DESIGN REVIEW BOARD – SPECIAL HEARING

Design Review Board Case # 2021-0001
Block 23 – 2121 and 2111 Eisenhower Avenue

I. Block 23 – DRB Concept Review

Above: Applicant’s initial massing proposal, showing parallel tall sections aligned N-S

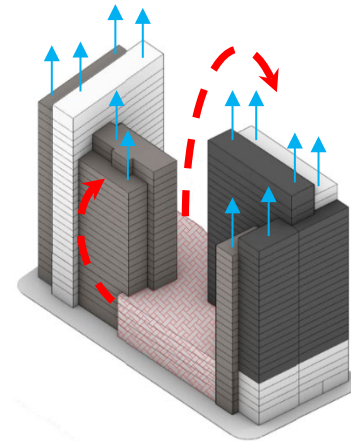
The first concept discussed with Staff incorporated two parallel towers, each with its primary mass oriented north-south and perpendicular to Eisenhower Avenue, with a secondary wing at ninety degrees, parallel to Eisenhower. Staff felt that this resulted in a “twin towers” or “bookends” effect, did not reflect an appropriate level of distinction between the two phases, and was also too similar to the parallelism already present in the Paradigm development to the immediate west of the project site.

Staff encouraged the Applicant’s design team to explore placing the buildings in a rotated relationship, to create a richer combination of forms – specifically, to let the dominant bar of one remain oriented north-south, while flipping the dominant bar of the other tower to an east-west alignment. Staff further encouraged applicant to develop strongly differentiated skin treatments for each tower, to carry tower architecture all the way to the ground wherever appropriate, and to use the portion of the screened garage that fronts on Eisenhower Avenue to create an element that reads as strongly different from the two towers (for example, horizontal in emphasis, and possibly much more glassy in terms of cladding) with the goal of further emphasizing the dramatic height of the two new residential towers. Applicant has incorporated these comments in their DRB submission, which will be reviewed in this hearing.

Attachment #1: Updated Massing / Height Study
Dated 6.9.2021

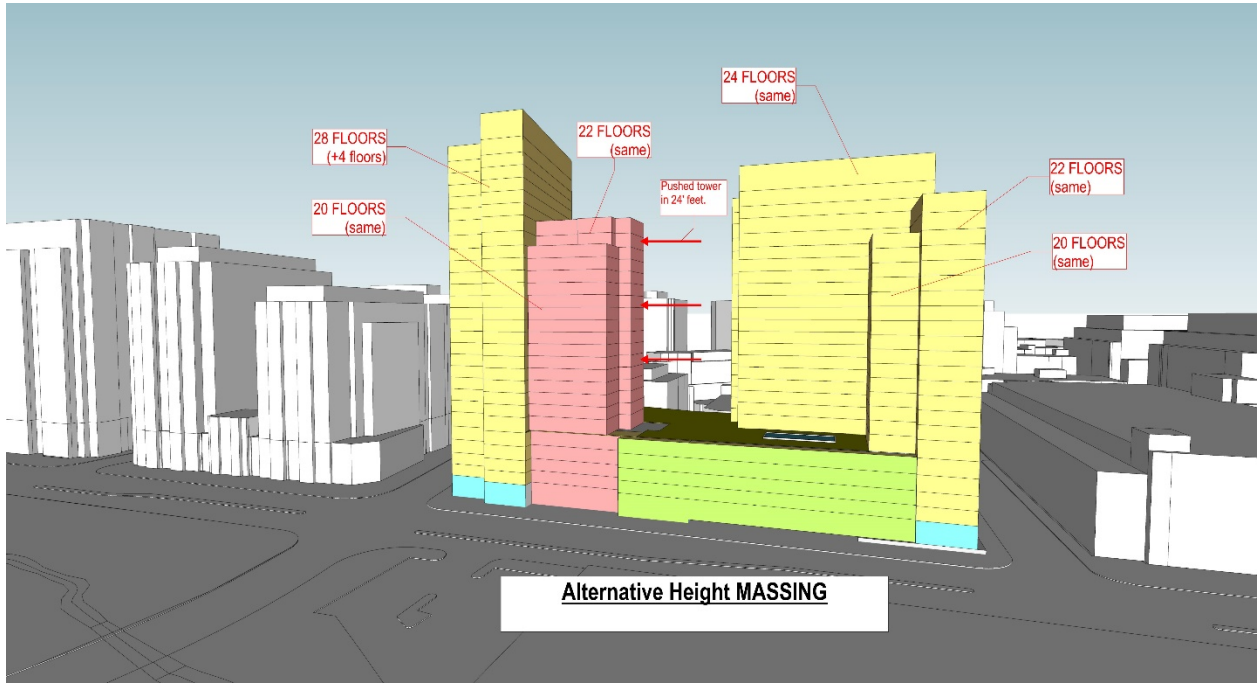
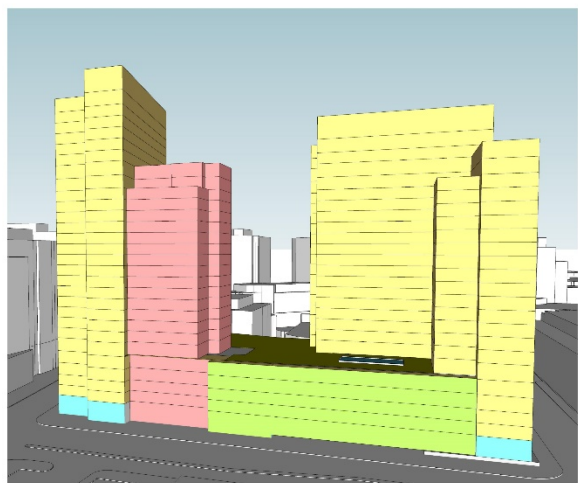
It should be noted that Staff received an updated analysis of this design option from Applicant following the formal DRB submission and have included them as an addendum to this report. If deemed appropriate, Staff hope to include this in their discussion with the DRB.

Applicant to study options for creating a more varied skyline, including through the introduction of additional height to one of the towers through the EESAP mechanism discussed above
